MITIGATION PLAN

Revision #2

**UT West Branch Rocky River Restoration Site
Mecklenburg County, North Carolina
DMS Project Number 92684
DEQ Contract Number D16015i
USACE Action ID: SAW-2017-00342**

Re: NCIRT Review and USACE Approval of the UT to West Branch Rocky River Mitigation Plan;
SAW-2017-00342; NCDMS Project # 92684

DATE: NOV 2018
 SCALE: GRAPHIC
 PLANTING PLAN
 SHEET 11 OF 12

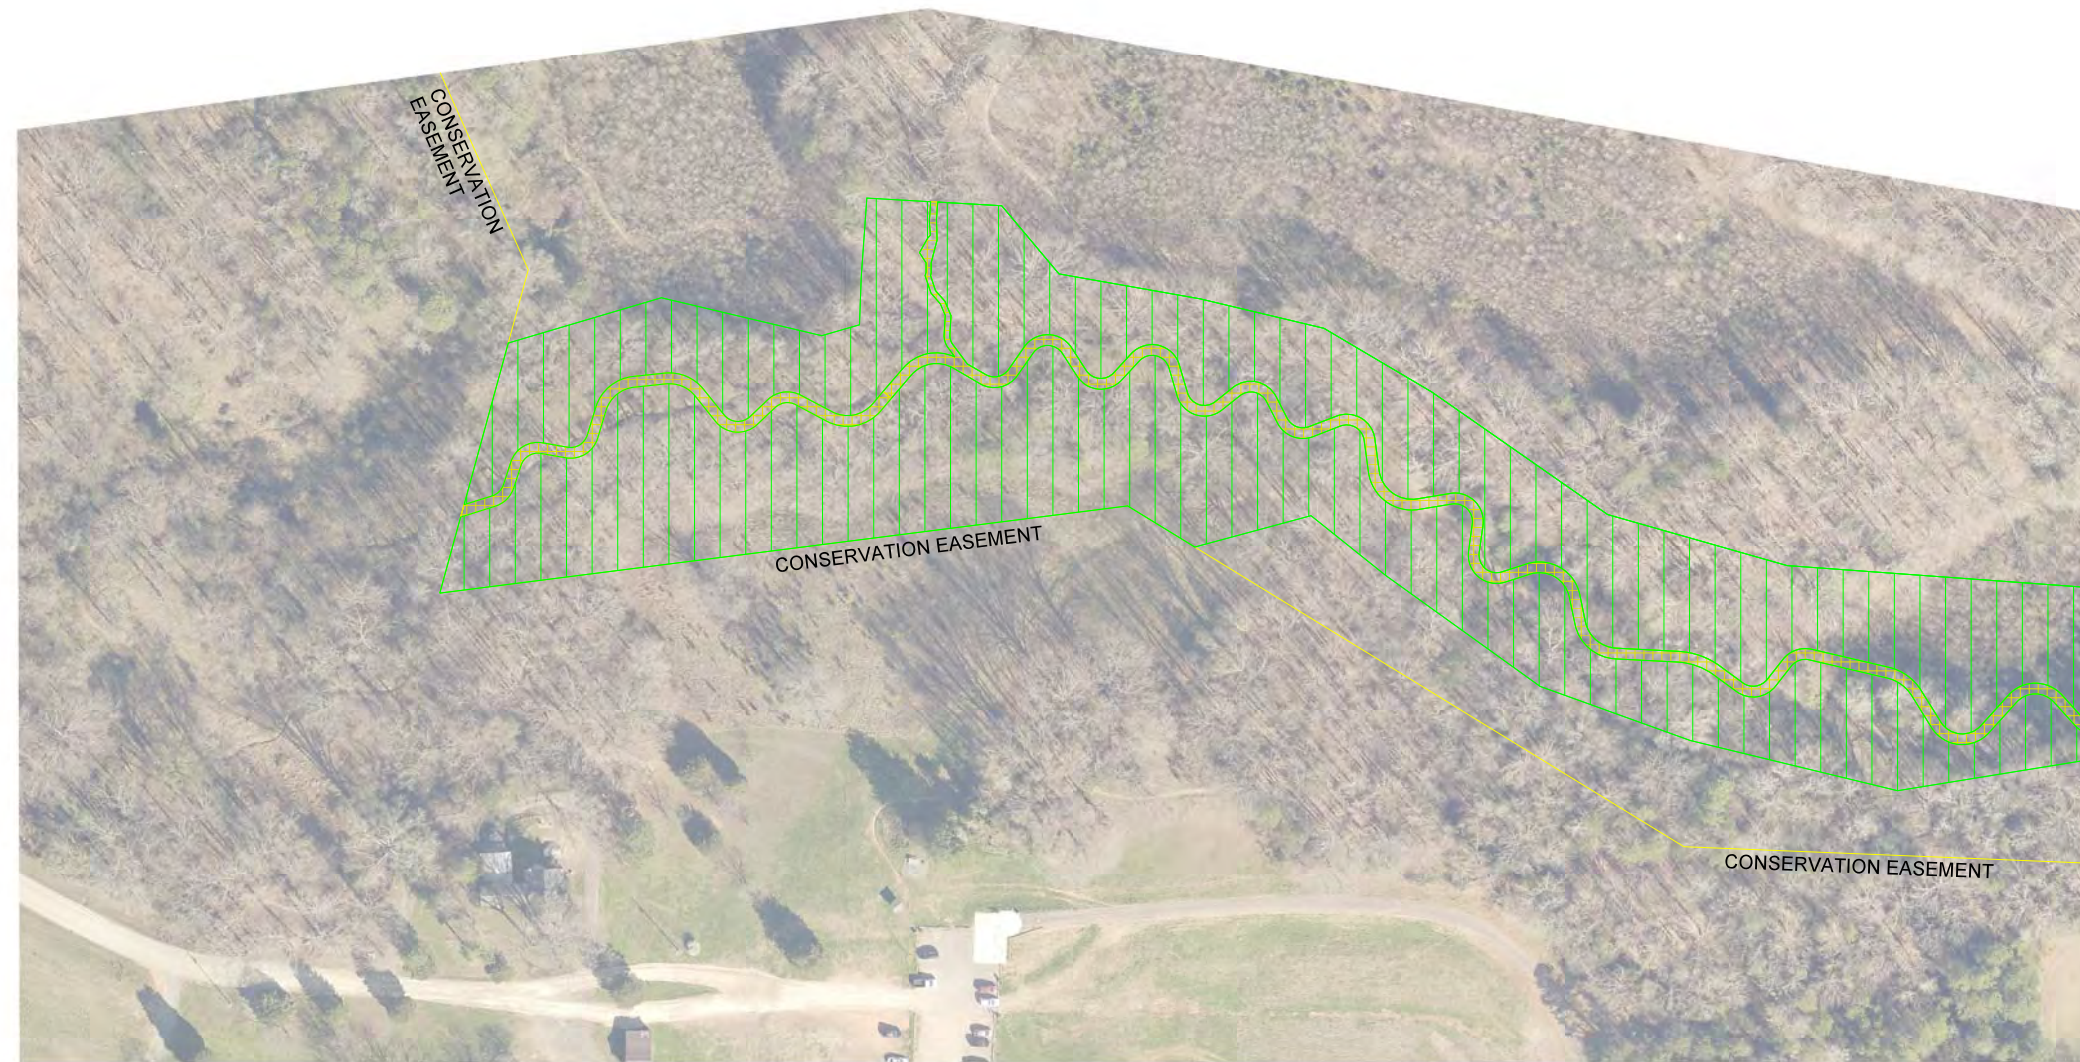
8. Section 6.7/Page 31 Planting: Recommend removing *Acer rubrum* (red maple) from the planting plan (Page 31 and Sheet 11) and replacing it with a suitable oak species.

Acer rubrum has been eliminated from the planting plan and several additional oaks among other species have been added.
